PRODUCT CHANGE NOTICE

PCN/EOL#16-037

ZN4PD1-63W-S+

Discontinuation of ZN4PD1-63W-S+ and replacement by ZN4PD1-63HP-S+

ORIGINAL PART: ZN4PD1-63W-S+

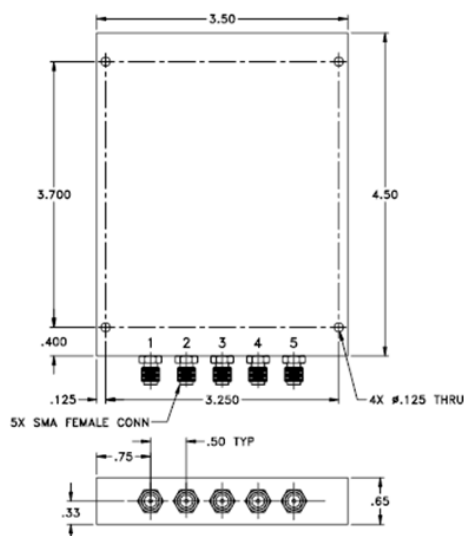
Case Style Change from

UU846 to UU846-4

REPLACEMENT PART: ZN4PD1-63HP-S+

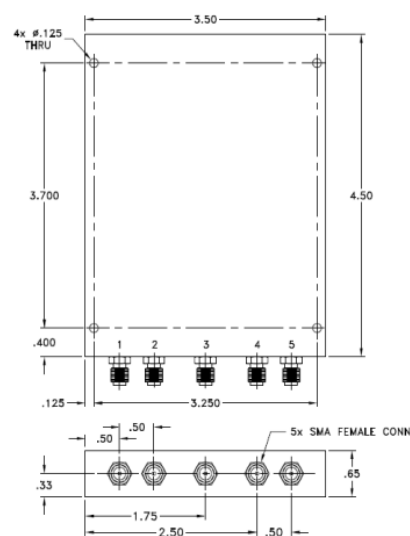
In new outline UU846-4, connectors at location 1 and 2 are moved on the left side by .25" (6.35mm) and connectors 4 and 5 are moved on the right side by .25" (6.35 mm).

Internally, PCB material is changed from OAK to TLP.

PERFORMANCE COMPARISON CURVES (TYPICAL)

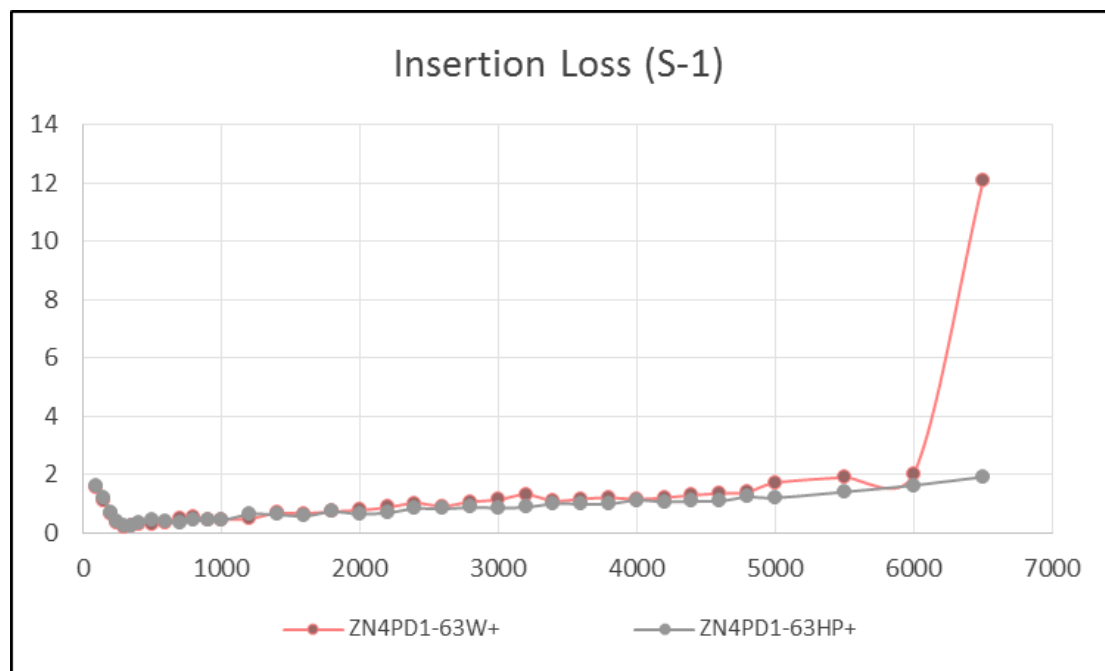
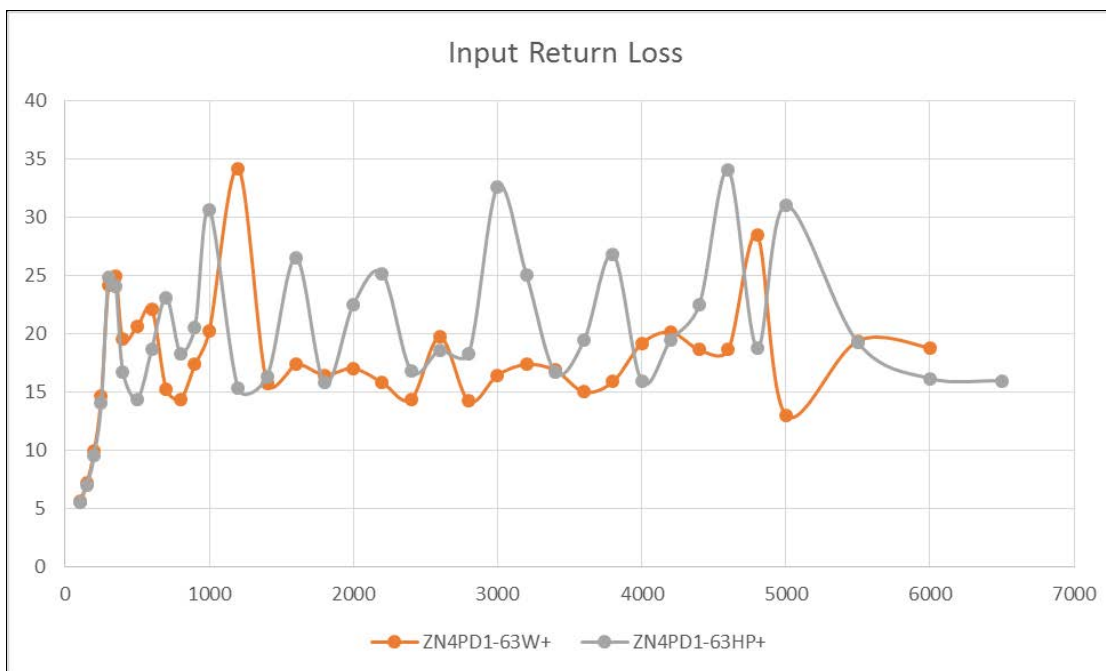
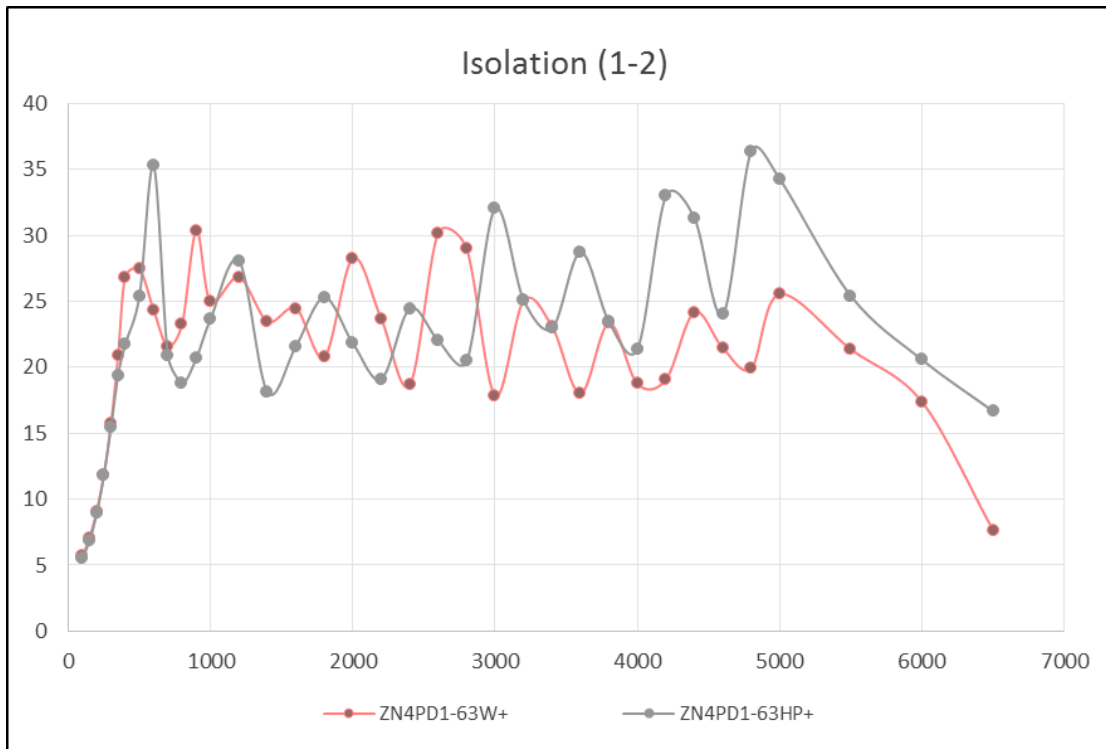
Unit is a functional alternative with improved performance.

Following is a summary of changes/improvements. Typical performance curves are given below
